STAFF REPORT
COMMUNITY DEVELOPMENT DEPARTMENT

HEARING DATE: 8/4/2022
TO: Planning & Zoning Commission
FROM: Alan Tiefenbach, Associate Planner
208-884-5533
SUBJECT: AZ H-2022-0038
Torino Locust Grove Subdivision
LOCATION: 870 S. Locust Grove Rd.

Annexation of 1.03 acres of land with the R-8 zoning district, and short plat consisting of 4 residential building lots.

A. Annexation and Zoning Legal Description and Exhibit

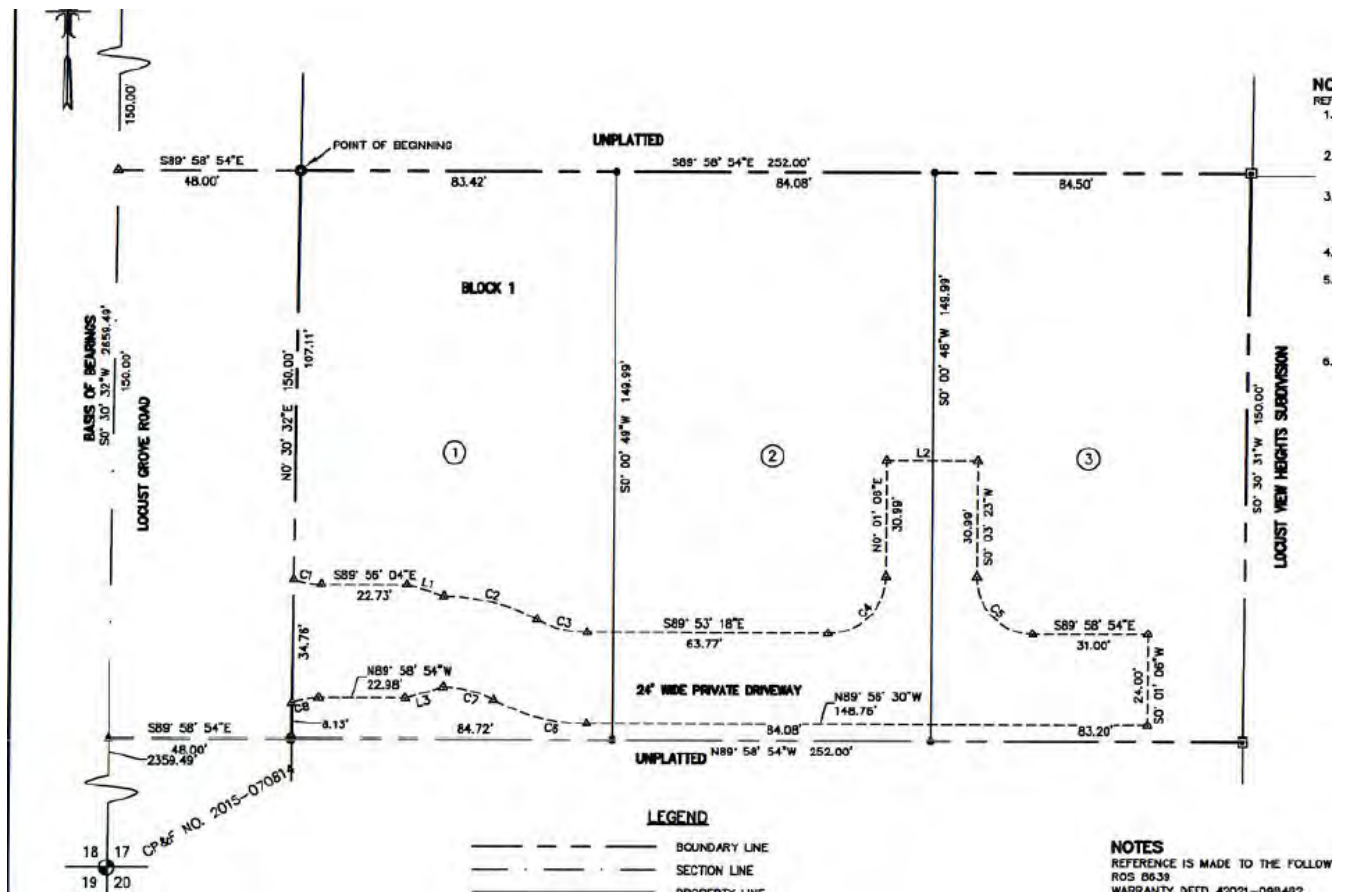
The submitted legal description and boundary exhibit to appear to encompass the area of annexation. However, the exhibit also includes a previous lot configuration of three lots. **Prior to recordation of the annexation ordinance, the applicant shall submit a revised boundary exhibit which correctly matches the legal description.**

3. Prior to recordation of the annexation ordinance, the applicant shall submit a revised annexation boundary exhibit.
 4. The applicant shall construct all proposed fencing and/or any fencing required by the UDC, consistent with the standards as set forth in UDC 11-3A-7 and 11-3A-6B, as applicable.
